ALLAWUNA LANDFILL FACILITY

SITA Australia

**ALLAWUNA FARM LANDFILL
SUPPLEMENTARY REPORT**

February 2015

**COMPARISON BETWEEN MODIFIED AND
ORIGINAL LANDFILL FOOTPRINTS**

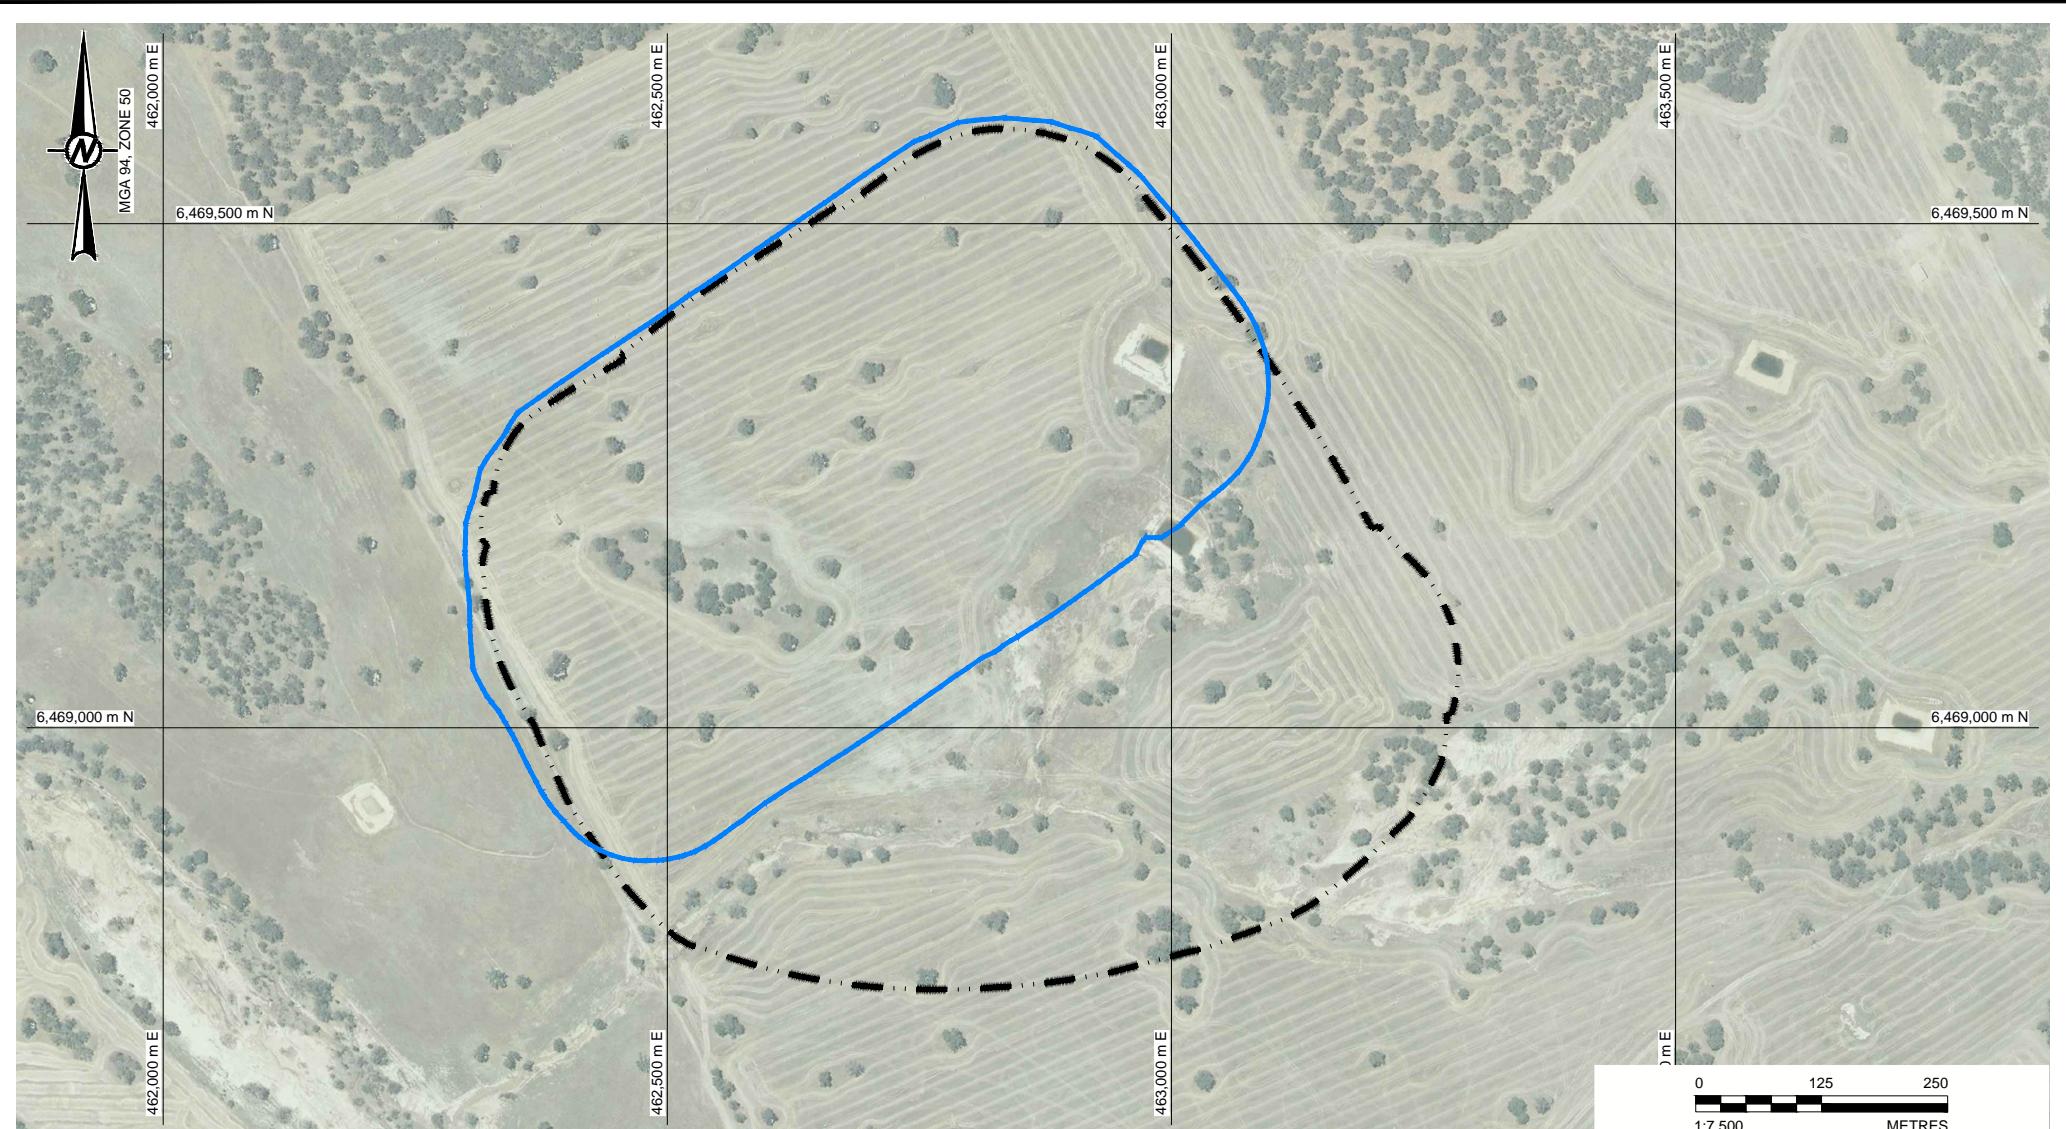
- Do not change the position of the Landfill within the Allawuna Farm [Figure 1 : Comparison Modified and Original Landfill Footprints];
- Do not change the composite liner system designed to protect the surrounding environment from the potential impacts of leachate and Landfill gas migration;

- Reduce the area of the Landfill footprint by approximately 31% from 52ha to 36ha;
- Reduce the maximum height of waste deposited from 355m to 350.5m ;

- Raise the floor of the Landfill to ensure a minimum clearance of at least 2m between the base of the Landfill and the maximum estimated winter groundwater level;

The modified Landfill has been confined to the northern half of the original footprint to avoid the lower areas of the valley where the depth to the winter watertable is the shallowest and has been reduced from

TITLE
MODIFIED LANDFILL
SECTION NORTH / SOUTH

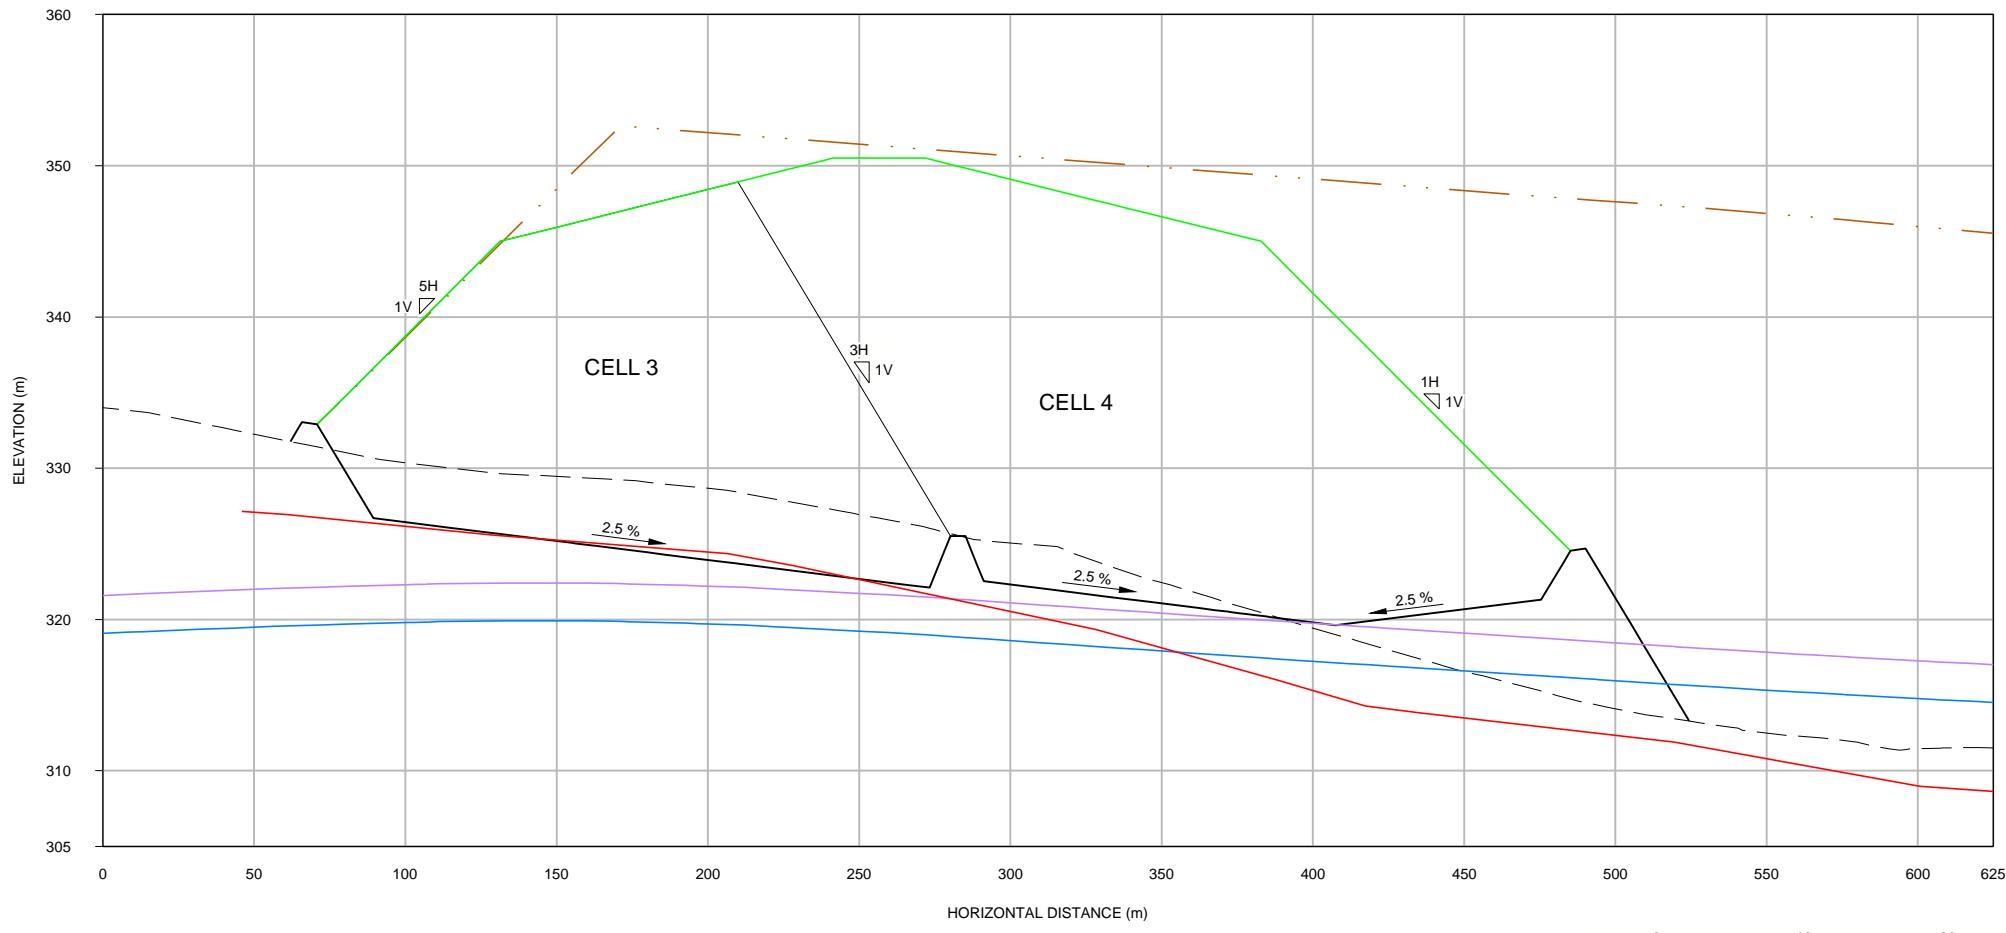
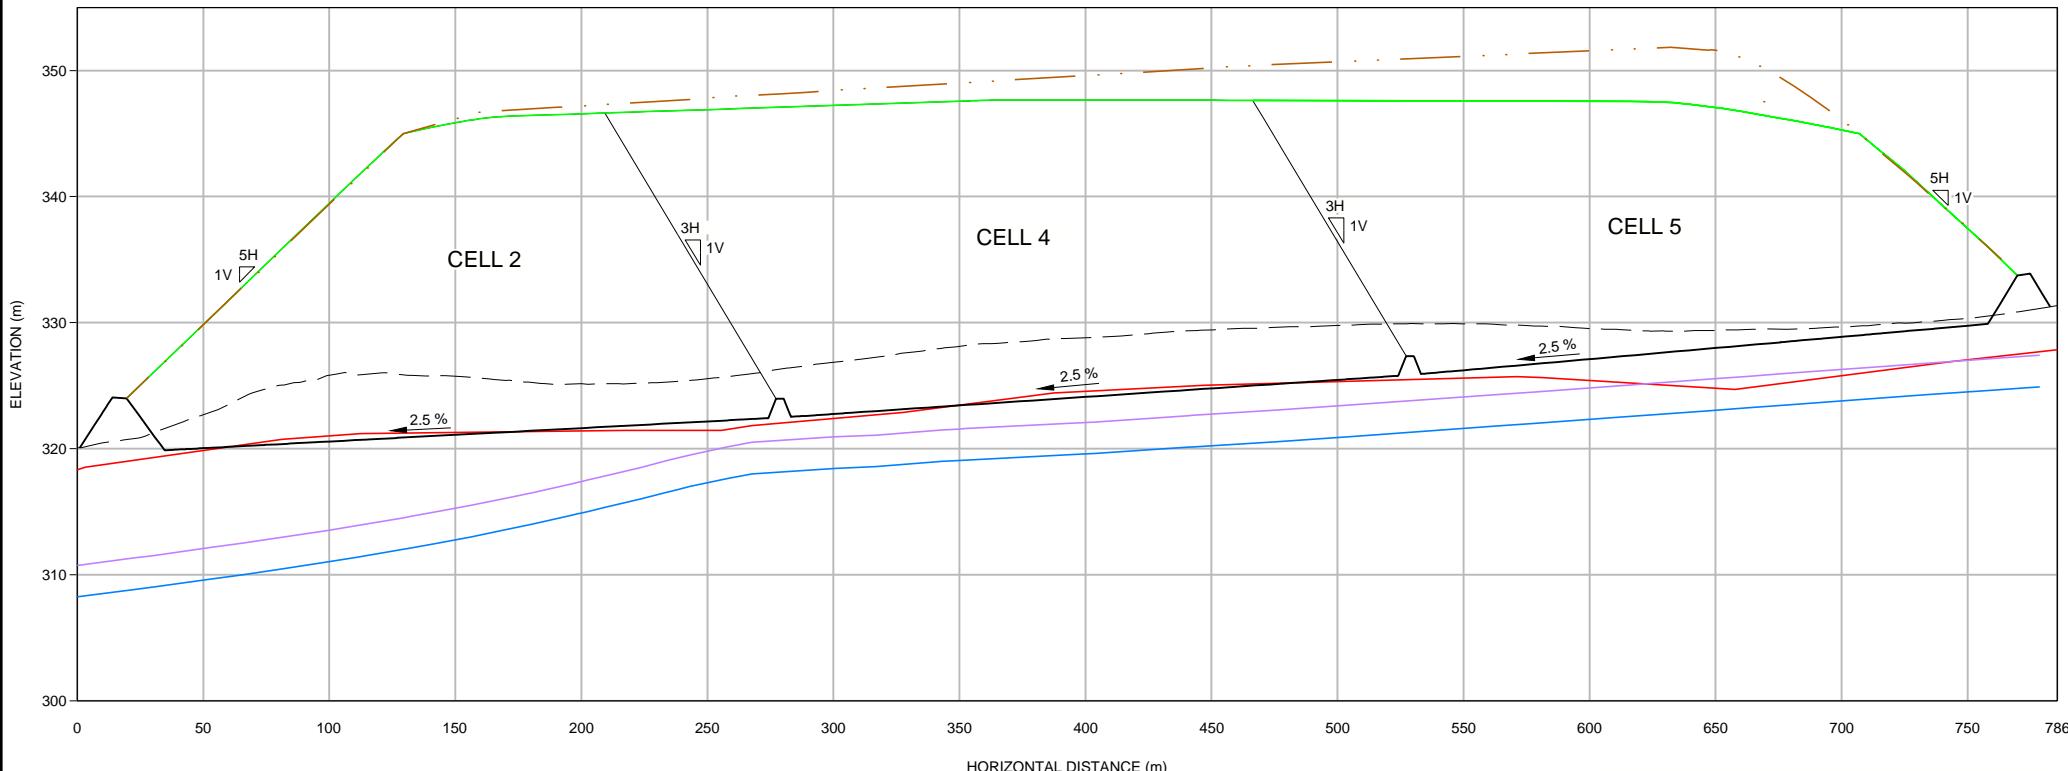
The overall height of the waste has been reduced from 355m AHD to 350.5m AHD [Figure 3 : Modified Landfill Final Form; Figures 4 & 5 : Modified Landfill Sections]

TITLE
MATERIAL BORROW PITS

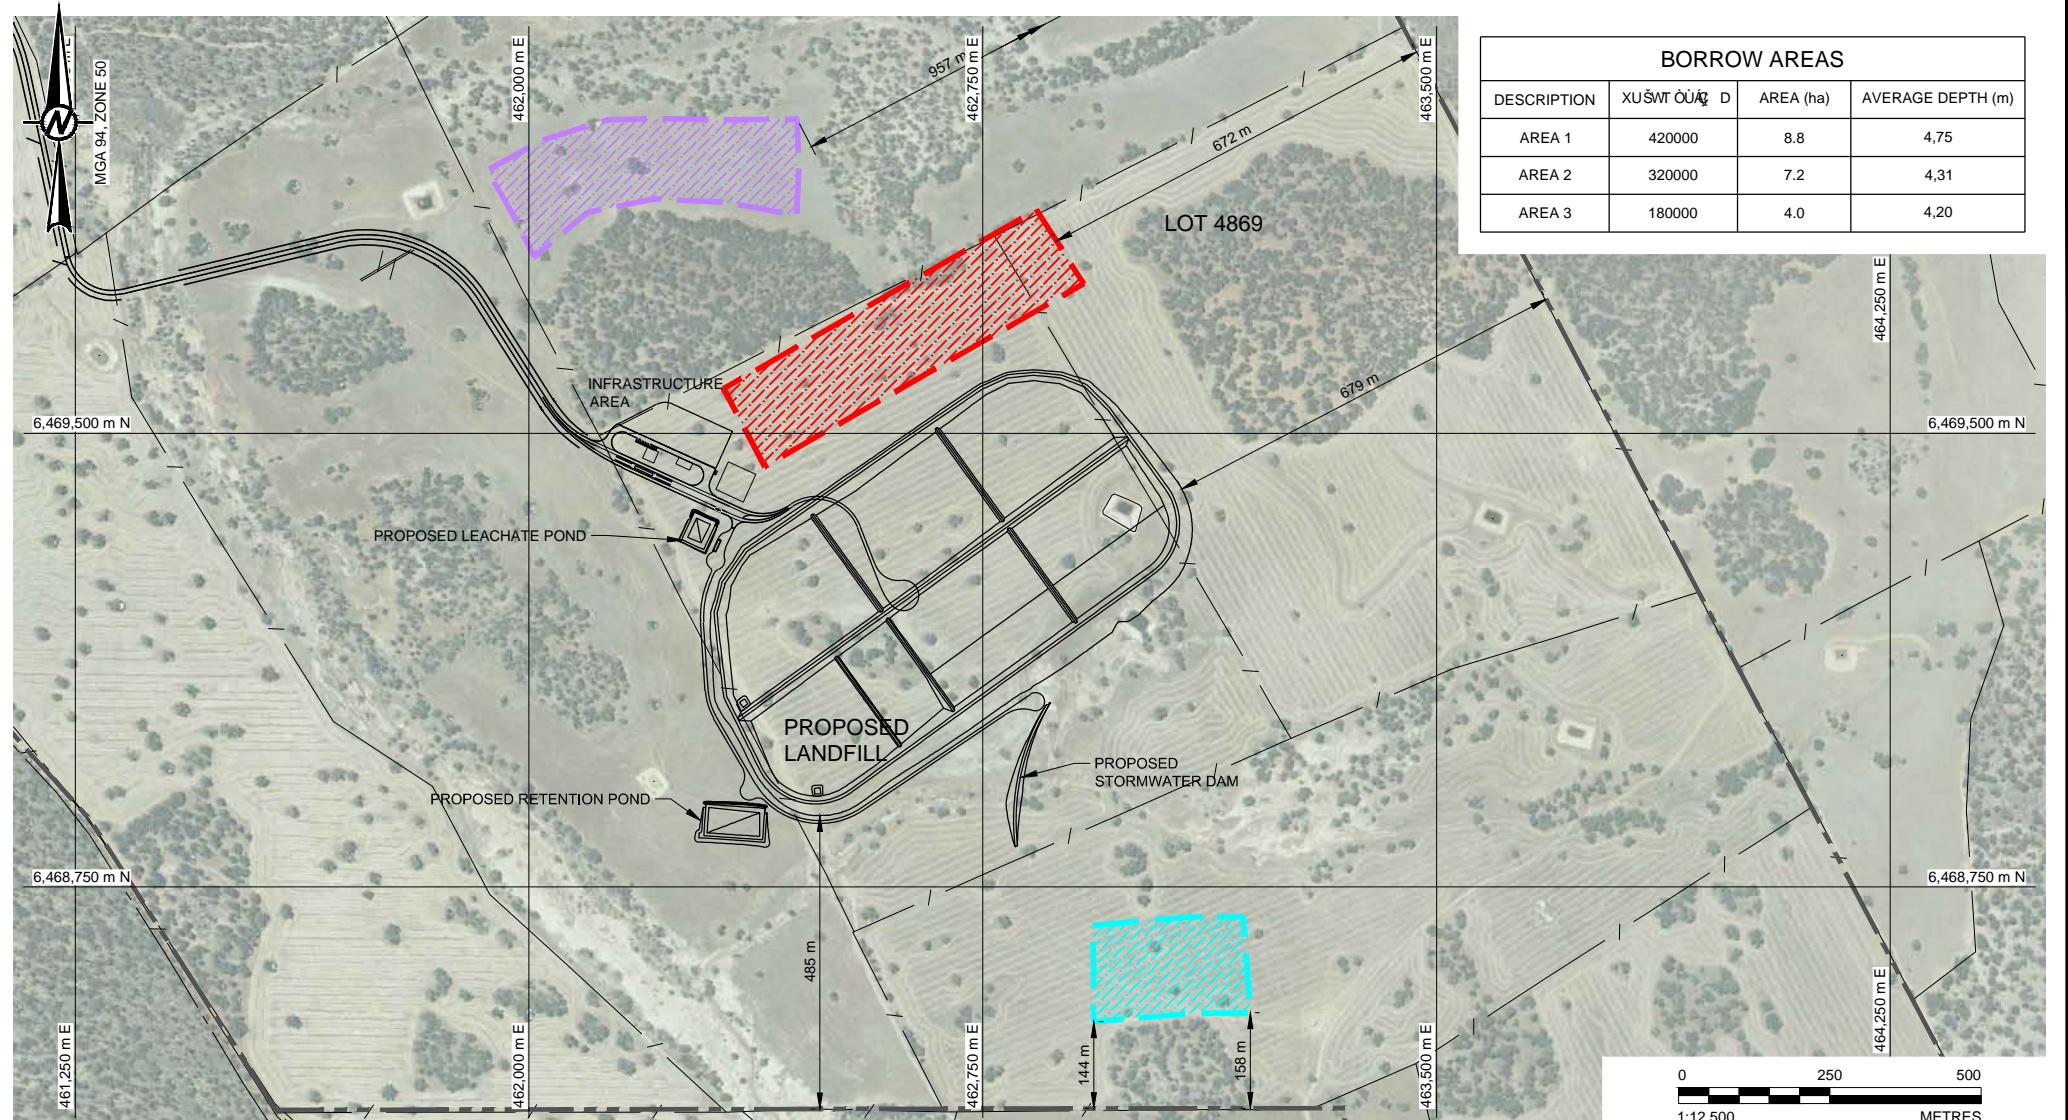
A total of 856,000 cubic metres of material is required and will be recovered from three borrow areas in close proximity of the Landfill and totalling 19.9 ha in area [Figure 6A : Materials Borrow Areas – Location].
